# Access Compliance Report

## Public Rights-of-Way

Intersection ID: 48472	Main Street: WONDERING_OAK_LN	Cross Street: TWIN_DR	Location: SW
ADA ID: A57FEFE6253D	Ramp Type: Perp	Initial Pass/Fail: Fail	Overall Compliance: No
Severity Score: 33.75			
Codes/Mitigation Info/Possible Solution		Field Measurements/Component Compliance

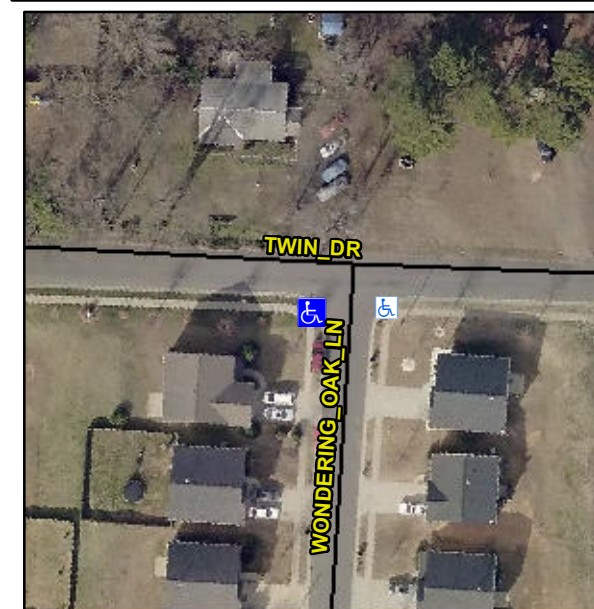
**Remove & Replace Entire Ramp.**

**Not Found, R304.5.1, R304.2.2**
